SITE PLAN REVIEW

LOT NO. 76 REGISTERED PLAN
THE PROPOSED LOT GRADING AND DRAINAGE IS APPROVED
AS BEING IN CONFORMITY WITH THE OVERALL APPROVED
GRADING PLANS FOR THE SUBDIVISION

JOHN TAYLOR STREET

PROJECT
14002

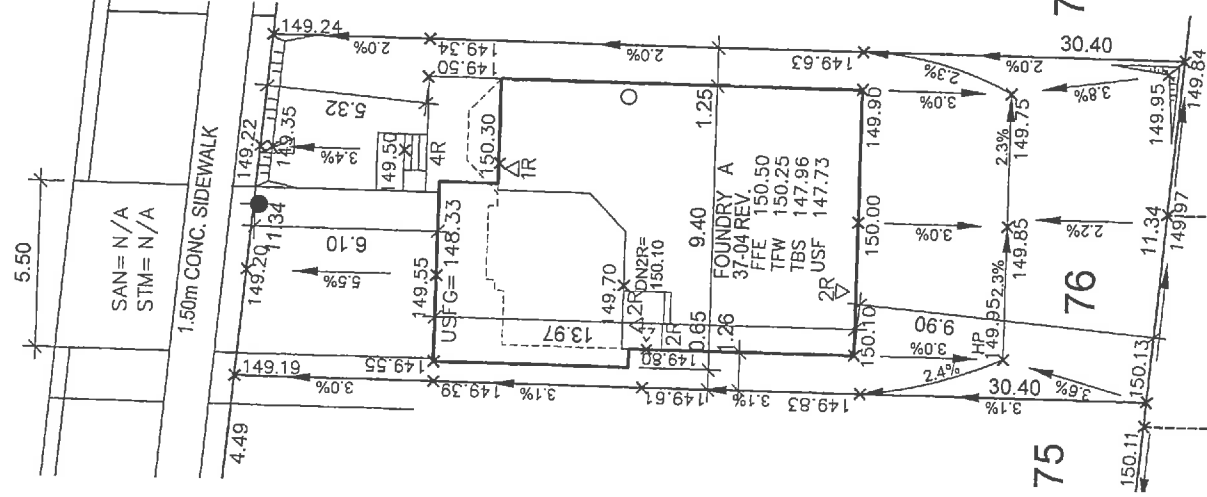
THIS PROPOSAL CONFORMS WITH THE MUNICIPALITY'S GRADING CRITERIA AND APPROVED SUBDIVISION MASTER LOT GRADING PLAN AND THE PROPOSED HOUSE TYPE IS COMPATIBLE WITH THE GRADING. THE PROPOSED DRIVEWAY LOCATION DOES NOT CONFLICT WITH ADJACE DRIVEWAYS, WALKWAYS, CATCHBASIN, HYDRANT, VALVE OR ANY STREET UTILITY.

NO COMMENT ☒ REVIEWED BY *[Signature]*
COMMENTS AS NOTED ☐ DATE *Dec 7, 2015*
